**Flood Control Project Maintenance  
Levee Inspections**

**Fall 2010 Levee Maintenance Deficiency Summary Report**

**Marysville Levee Commission**

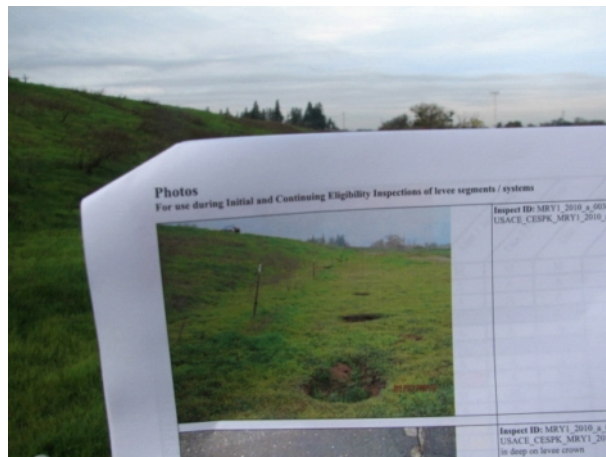
Levee Mile Report Line	1
Start Levee Mile	2.50
End Levee Mile	2.50
Location	Land Side
Category	Earthen Levee
Item	Crown Surface / Depressions / Rutting
This item was identified with an Unacceptable rating in the USACE PI report for the City of Marysville 1 Levee System (MRY1_2010_a_0036). Reinspect on 12/9/10 verifies that repairs were made as indicated in the 11/22/10 letter from the City.	
cathom_f_20101209_166.jpg
